**AREA 2 FIELD SAMPLING PLAN**

**ADDENDUM TO REMEDIAL INVESTIGATION**

**FORMER FORT DEVENS ARMY INSTALLATION, DEVENS, MA**

**DECEMBER 2018**

Figure  
1

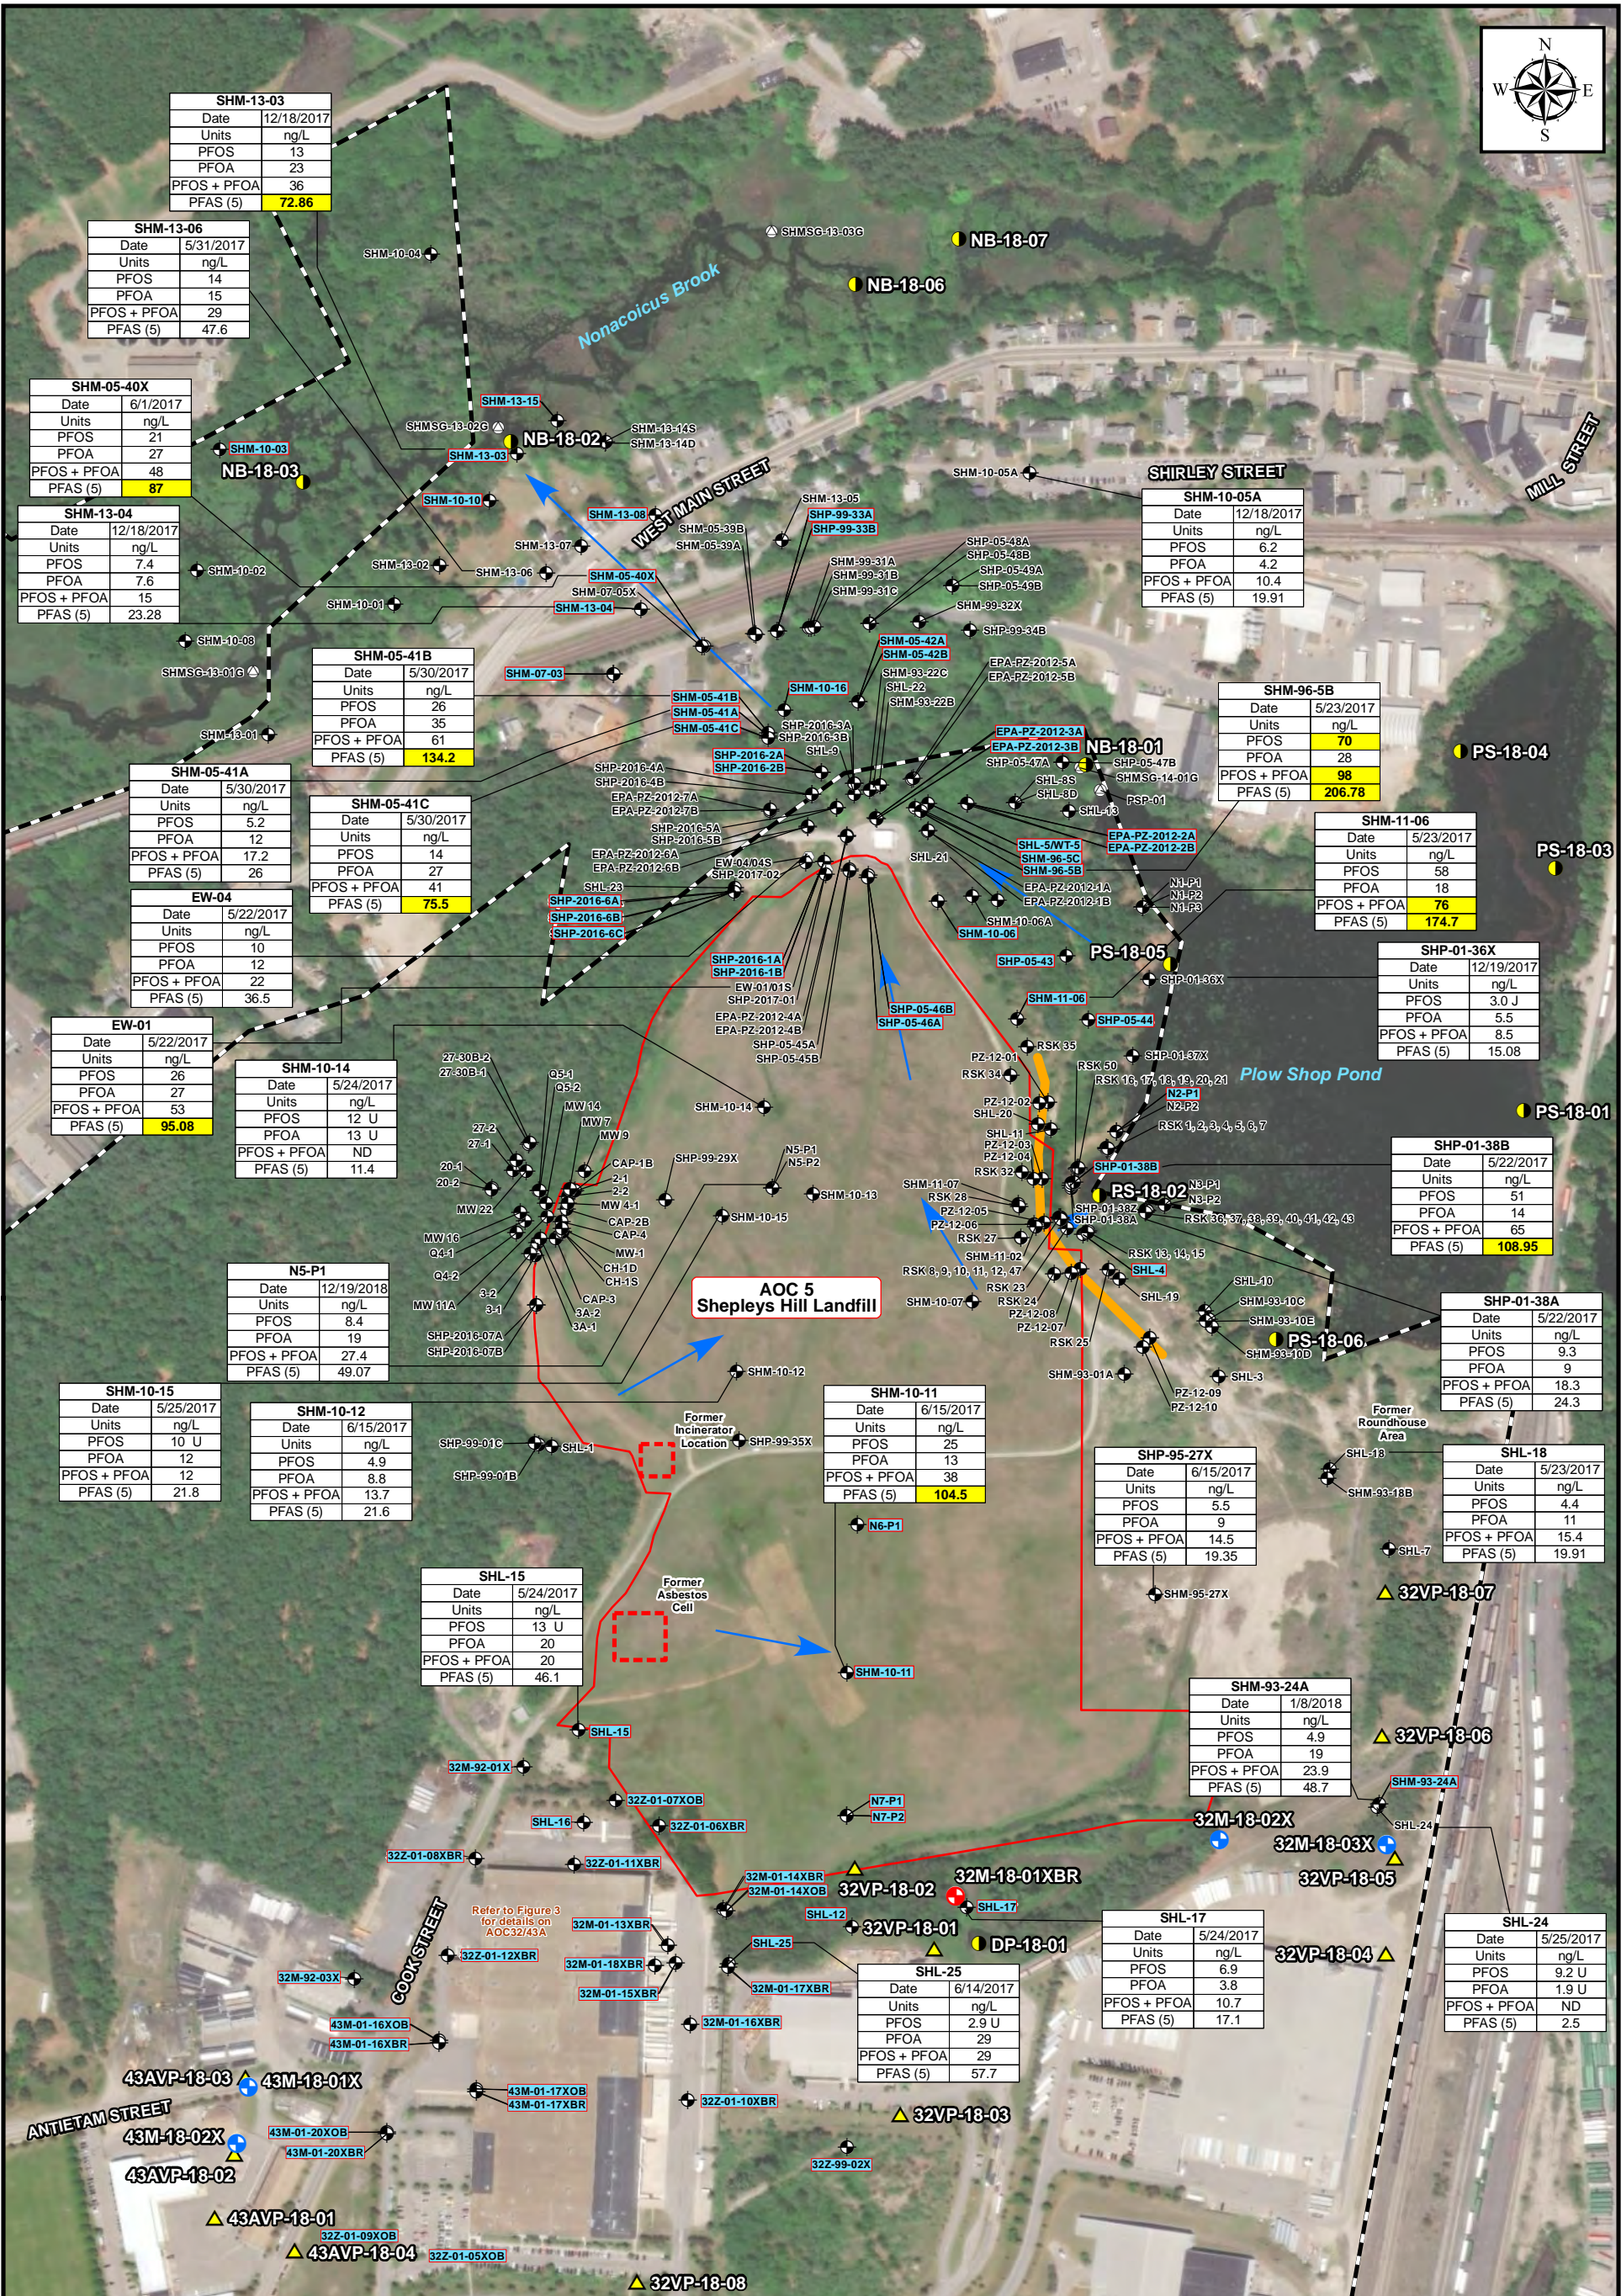
**Comment # 5:** Figure 1, Area 2, Figure Extents – Please include a symbol and label the MacPherson well on Figure 1.

**Response:** A symbol for the MacPherson water supply well will be added to Figure 1.

Figure  
3

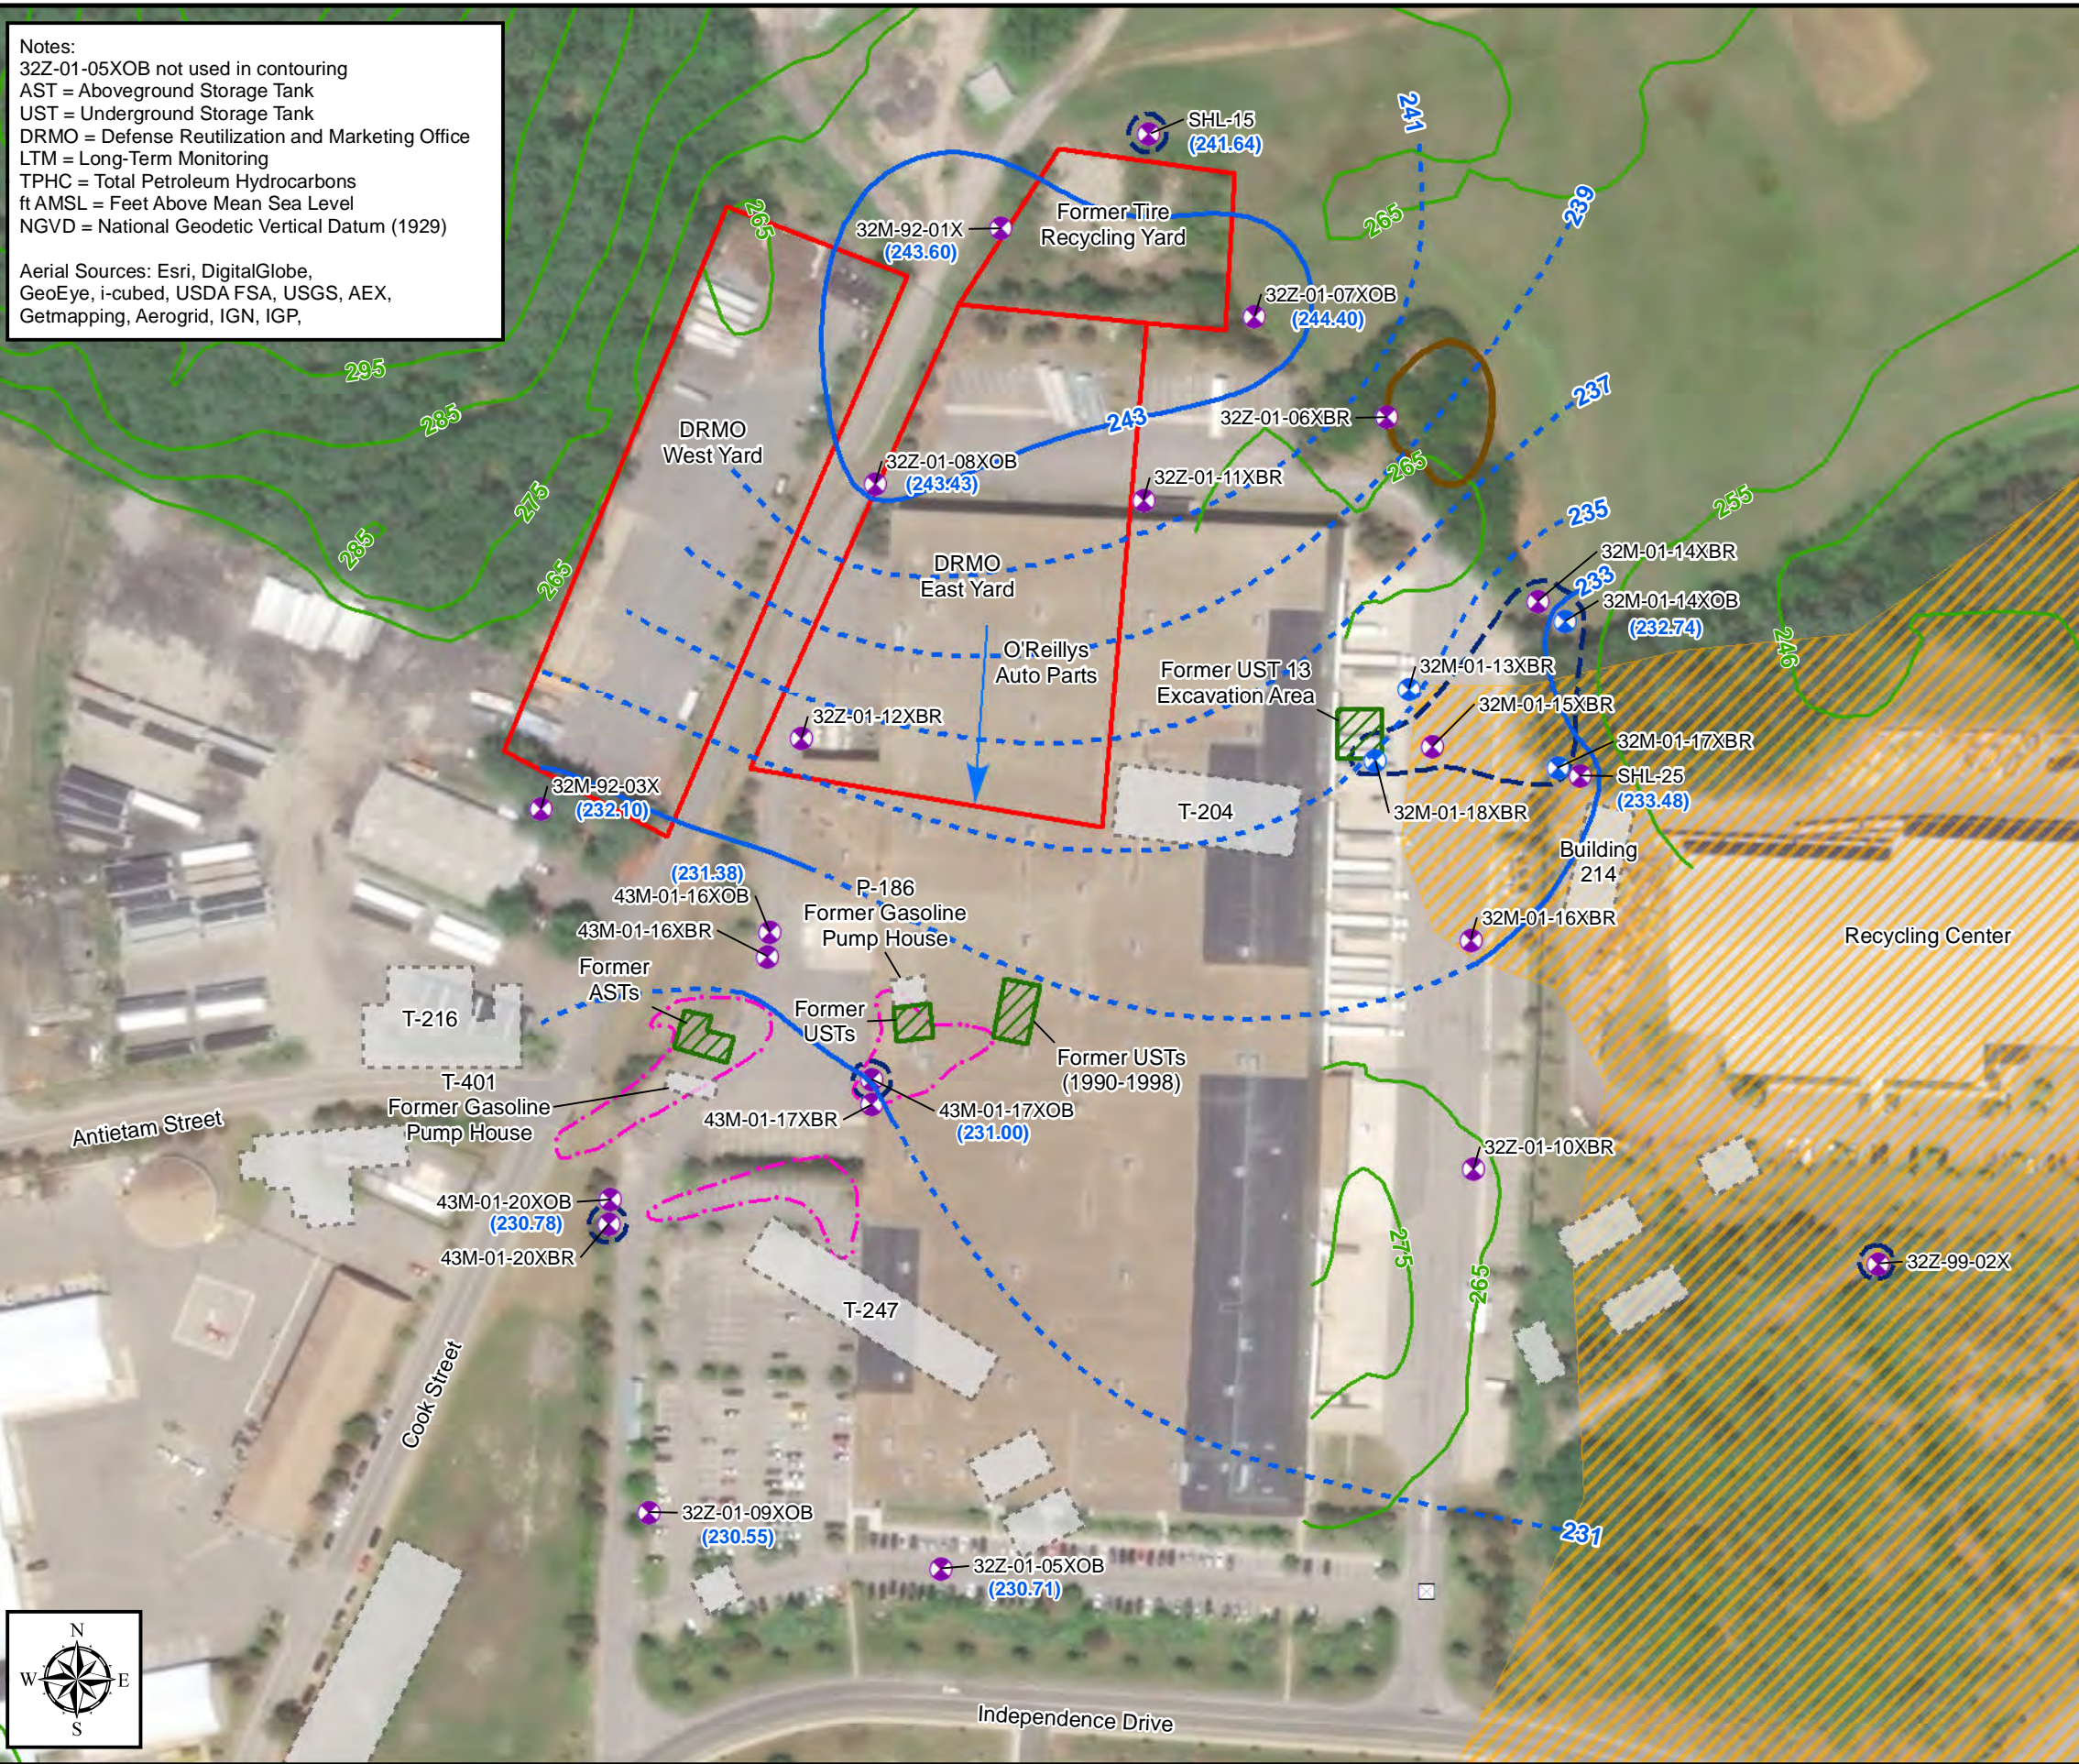
**Comment # 8:** Figure 3, AOC32/43A - Please edit the figure to outline the extents of the storage areas (east, west, and tires).

**Comment # 9:** Figure 3, AOC32/43A - Based on the water level data presented, the 234 contour looks questionable and could potentially extend to the northeast. The justification for the contour as presented is unclear. Also, 32Z-01-05XOB water level data appears to be a significant anomaly; is there other data supporting that water level?

**Comment # 19:** Table 5 – The rationale stated for vertical profiling locations 43AVP-18-01 through 43AVP-18-03 is to “Determine the extent of PFAS detections in groundwater downgradient of AOC 43A”, yet Figure 3 shows AOC 43A overburden groundwater flowing away from these proposed locations. Please clarify the rationale of these three vertical profiling points.

**Response:** The extents of the storage areas will be added to Figure 3.

**Response:** The 2017 water table elevations in overburden wells at AOC 43A are anomalous from previous depictions of water table elevations in overburden wells at AOC 43A. Historically, the shape of groundwater contours developed from overburden wells are similar to the groundwater contours developed from bedrock wells. Figures 3 and 4 will be revised to show the 2016 interpreted water table elevations as the 2016 elevations are more indicative of historic conditions.

**Response:** The 2017 water table elevations in overburden wells at AOC 43A are anomalous from previous depictions of water table elevations in overburden wells at AOC 43A. Historically, the shape of groundwater contours developed from overburden wells are similar to the groundwater contours developed from bedrock wells. Figures 3 and 4 will be revised to show the 2016 interpreted water table elevations as the 2016 elevations are more indicative
